SERVICE BULLETIN

APPLICABILITY: 2015-20MY WRX and WRX STI

NUMBER: 12-305-20

SUBJECT: Front Hood Intake Duct- Design Change

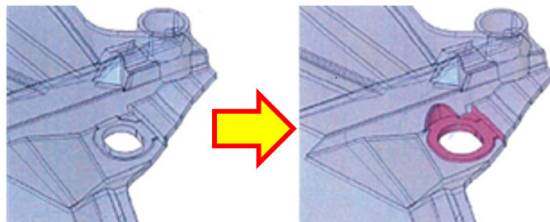
This bulletin announces a design change made to the front hood air intake duct used on the models listed above. The new duct utilizes larger holes at the attachment points to facilitate the use of mounting bolts with a larger shoulder (boss) diameter as shown (in green) in the illustrations below. For this reason, the new mounting bolts are not interchangeable and cannot be used with the original style duct.

OLD DUCT

NEW DUCT

OLD BOLT

NEW BOLT

- New Mounting Bolt: **901020030**
- New Duct-Inner Front Hood: **57253VA011**
